TDECQ Calculation Method

Addressing comments #94, #95, #96, #97, #98, #99, #100, #101, #102, and #103 against IEEE P802.3dj D3.1

- The suggested remedy below shall replace the text in clause 180.9.6.4 starting from page 484 line 6 and ending on page 487 line 24 in draft 3.1.

Figure 180-11—Illustration of the TDECQ measurement

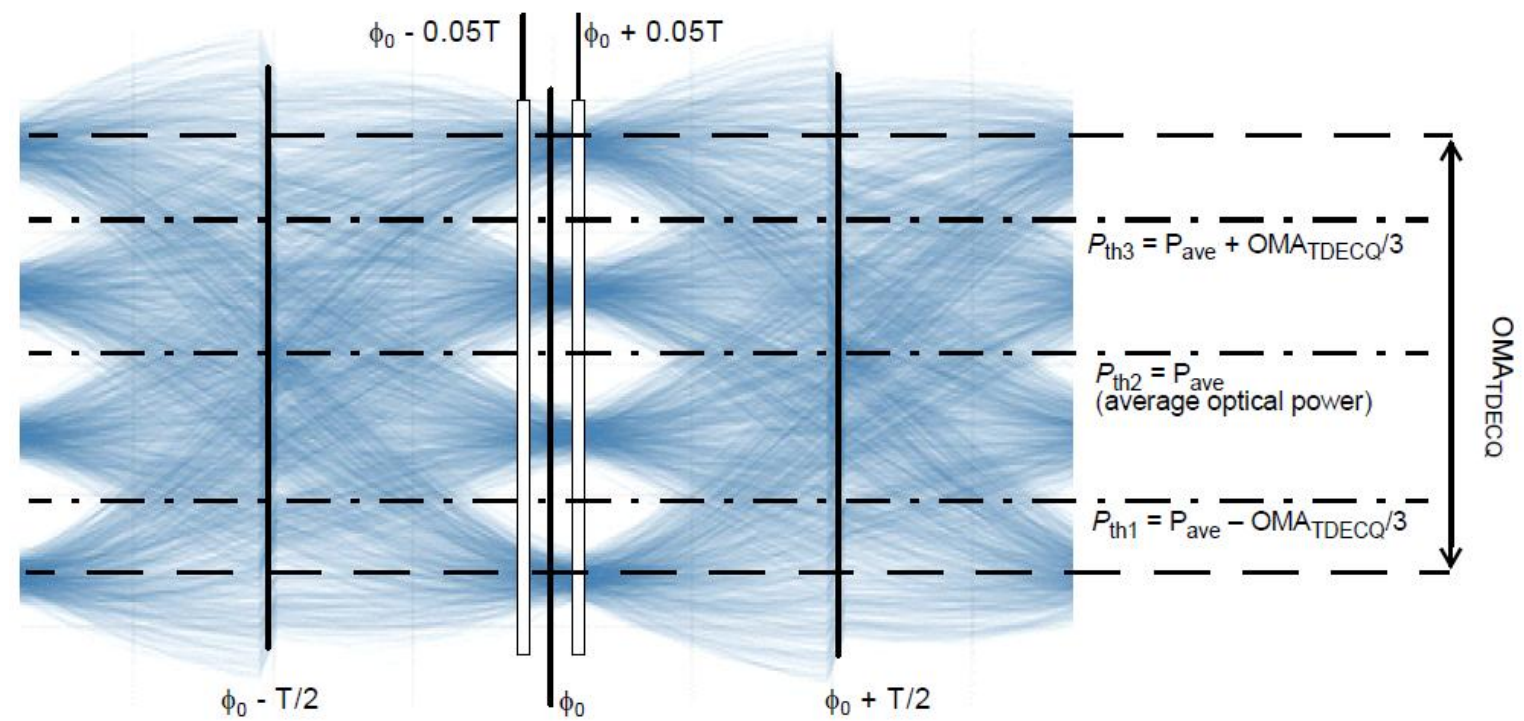
The nominal sub-eye threshold levels P_{th1} , P_{th2} , and P_{th3} , are determined from the OMA_{TDECQ} and the average optical power of the eye diagram (P_{ave}) as defined in the following equations and illustrated in the figure

Editors note: The histogram windows are shown in a non-ideal locations and should be centered.
